STAFF RECOMMENDATION
2116 19th Avenue South
January 16, 2019

Application: New Construction—Infill
District: Belmont-Hillsboro Neighborhood Conservation Zoning Overlay
Council District: 18
Map and Parcel Number: 10416002600
Applicant: Stewart Bronson, Stone Oak Builders
Project Lead: Melissa Sajid, melissa.sajid@nashville.gov

<p>Description of Project: The request is to construct a two-story infill building.</p> <p>Recommendation Summary: Staff recommends approval with the following conditions:</p> <ol style="list-style-type: none">1. The finished floor height shall be consistent with the finished floor heights of the adjacent historic houses, to be verified by MHZC staff in the field;2. The front setback should be consistent with the buildings to either side, to be verified by MHZC staff in the field;3. The HVAC shall be located at the rear of the home or on the side, beyond the mid-point of the house; and4. Staff shall review all final material selections including a brick sample prior to purchase and installation. <p>With these conditions, staff finds that the project meets Section II.B of the <i>Belmont-Hillsboro Neighborhood Conservation District: Handbook and Design Guidelin

PROPOSED SITE PLAN
OF
2116 19th AVENUE S.
NASHVILLE, TN 37212

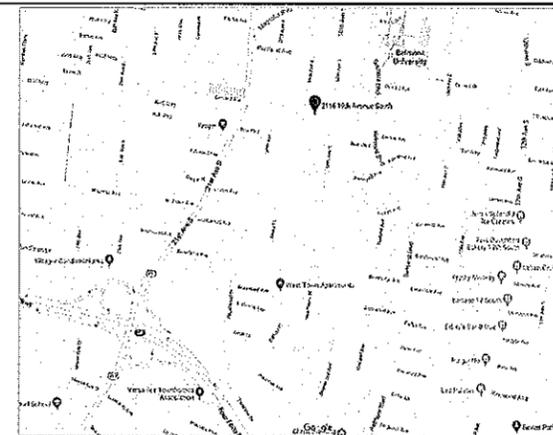
Analysis and Findings: The request is to construct a two-story infill. The site plan includes the footprint of a detached garage; however, that is not included with this application.

Setback & Rhythm of Spacing: The primary building is centered on the lot, similar to other historic buildings found in the district. The house is setback forty-six feet (46') from the front property line, which is approximately the average of the front setbacks of the houses to either side. Both side setbacks are approximately seven feet (7'), and the structure is thirty feet (30') from the rear property line. The proposal meets all bulk zoning setback requirements.

1. The finished floor height shall be consistent with the finished floor heights of the adjacent historic houses, to be verified by MHZC staff in the field;
2. The front setback should be consistent with the buildings to either side, to be verified by MHZC staff in the field;
3. The HVAC shall be located at the rear of the home or on the side, beyond the mid-point of the house; and
4. Staff shall review all final material selections including a brick sample prior to purchase and installation.

FRONT ELEVATION

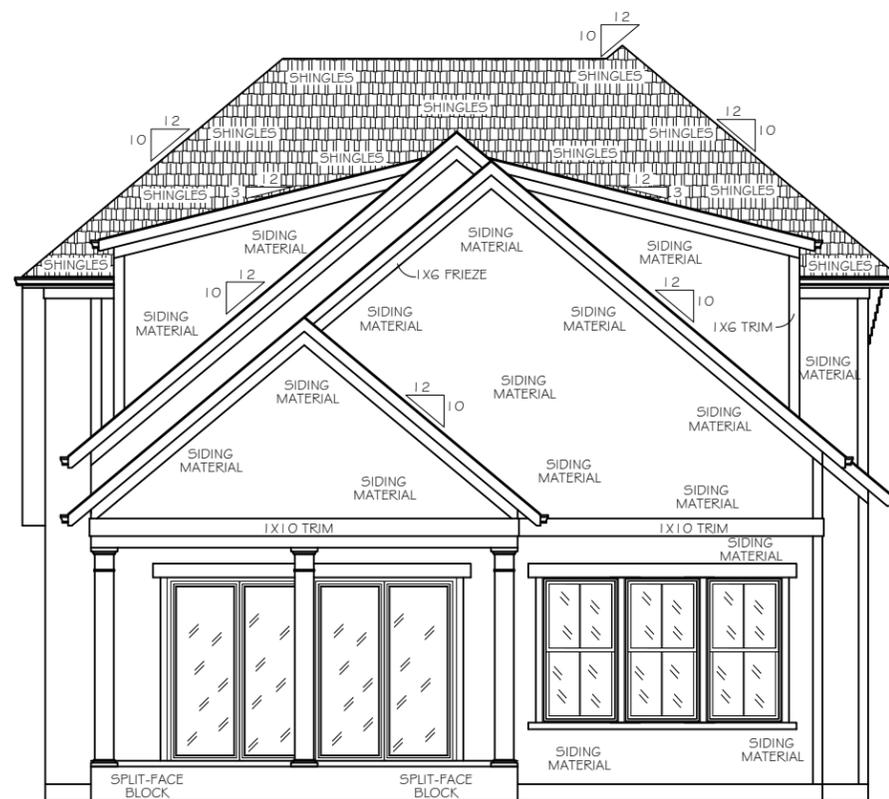
Height & Scale: The proposed dwelling is two stories with one and one-half story components and is thirty-three feet (33') from grade to ridge. The majority of homes in the immediate context are one-and one-half and two stories. The historic house at 2112 19th Avenue South, located two houses to the left of the site, is one and one-half stories

but reads as two-stories because of a tall and steep gambrel roof form that includes a front dormer that extends almost the entire width of the house. The house at 2112 19th Ave South is approximately thirty-two feet, three inches (32' 3") from grade. The Commission approved a two-story infill next door at 2114 19th Avenue South in 2012 that is thirty-three feet (33') tall from grade to ridge.

Roof form: The roof form is a combination of a front gabled and a hipped roof form, both with a 10/12 pitch. The plan incorporates shed dormers on both side façades of the rear facing gable that ties into the rear of the hipped roof form approximately three feet, six inches (3'-6") below the peak.

Orientation: The proposed structure has an asymmetrical façade with a centered front entrance and a porch located on the left portion of the front façade. The house is oriented to face 19th Avenue South, as are all of the buildings on this block. A walkway is proposed that connects the entrance to the street. Vehicular access to the infill will be from the alley.

Proportion and Rhythm of Openings: The windows of the proposed structure are approximately twice as tall as they are wide, with the exception of two smaller square

windows on the right side façade. The square windows are located near the rear on the right side on a portion of wall that sets in two feet (2') from the primary side wall, and therefore it is unlikely that those windows will be visible from the street. There is no large area of any of the façades without a window or door opening.
